1995 - 1996 Corvette: Service Bulletin: Delayed Engagement (Replace Pump Cover Assembly)

Subject: Delayed Engagement (Replace Pump Cover Assembly)

Bulletin Number: 67-71-48

FIGURE 3. - TORQUE CONVERTER CLUTCH SIGNAL VALVE ASSEMBLY
LOCATION

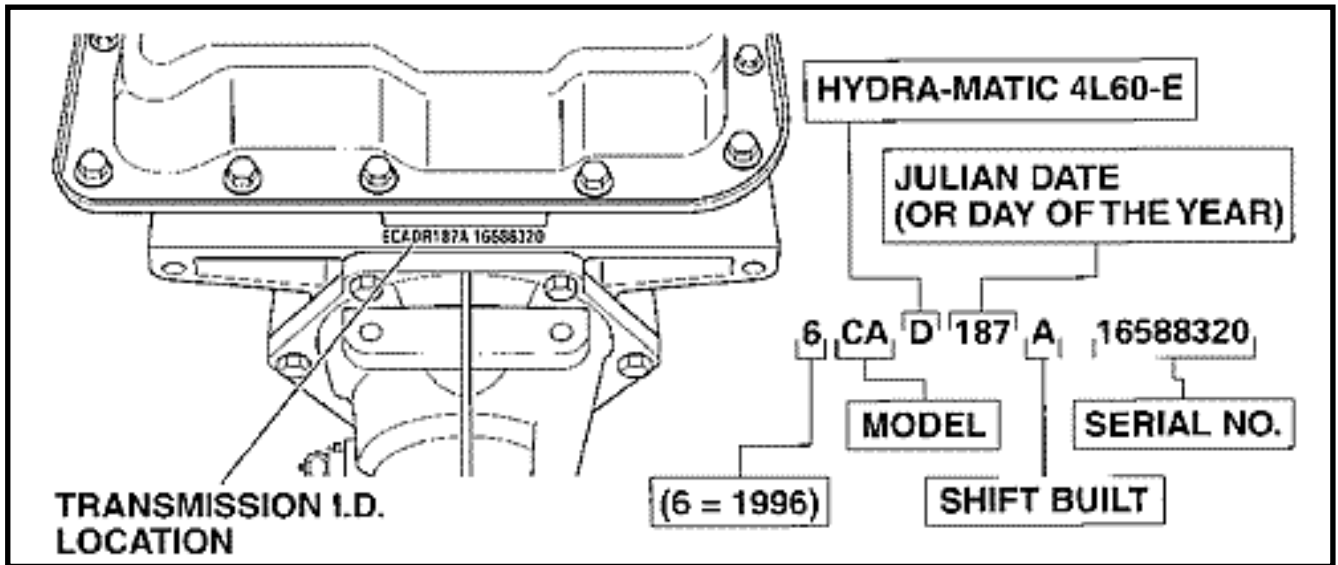
(FIGURE 3) REPLACE PUMP COVER ASSEMBLY WITH THE NEW TCC SIGNAL VALVE ASSEMBLY.
